# AMD Alchemy™ Au1500™ Processor

## Document Revision History

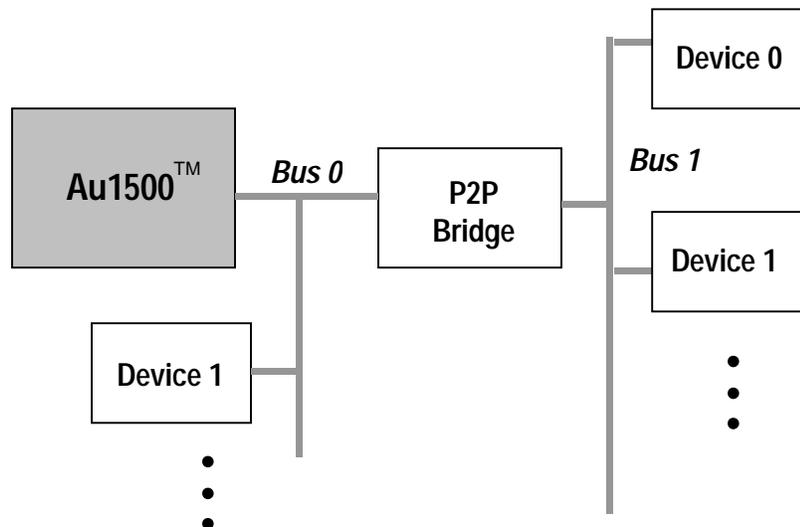
**32. The AMD Alchemy™ Au1500™ processor does not support PCI-to-PCI bridges.****Description**

The Au1500 processor does not support the use of mastering PCI devices "behind" PCI-to-PCI (P2P) bridges. A P2P bridge is a device which extends the PCI bus, allowing the addition of more devices than the timing or loading of one PCI bus segment can allow. This affects the Au1500 processor in both host and satellite modes.

The following diagram illustrates a multi-bus system where the Au1500 processor is the host, and devices exist on bus 0 and bus 1.

Configurations that are NOT Supported:

- Bus master devices on Bus 1 which target the Au1500 processor.
- P2P Bus Bridges cannot be used with the Au1500 processor in satellite mode. This may preclude the use of the Au1500 processor in some PCI board applications

Host Mode Configurations that ARE supported:

- All PCI devices which reside on the single Au1500 processor PCI bus (bus 0)
- All PCI mastering devices which reside on the Au1500 processor PCI bus (bus 0). The Au1500 processor includes a five-way arbiter supporting the Au1500 processor and four external mastering devices.
- All PCI slave devices which reside behind a bridge (bus 1)

None

**Table 77. Thermal Characteristics**

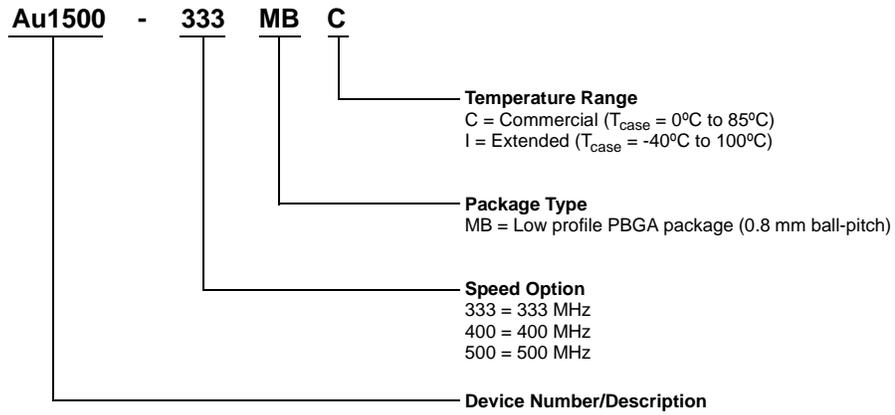
### 2. Table 73. Thermal Characteristics, page 279

The following table replaces “Table 73. Thermal Characteristics” in the *AMD Alchemy™ Au1500™ Processor Data Book*, 30361B.

Parameter	Air Flow					Unit
	0 m/sec 0 LFPM	0.25 m/sec 50 LFPM	0.5 m/sec 100 LFPM	0.75 m/sec 150 LFPM	1.0 m/sec 200 LFPM	
$\Theta_{JA}$	33.1	31.8	30.7	30.1	28.6	— °C/ Watt
$\Psi_{JT}$	—	—	—	—	—	5.0 1 °C/ Watt
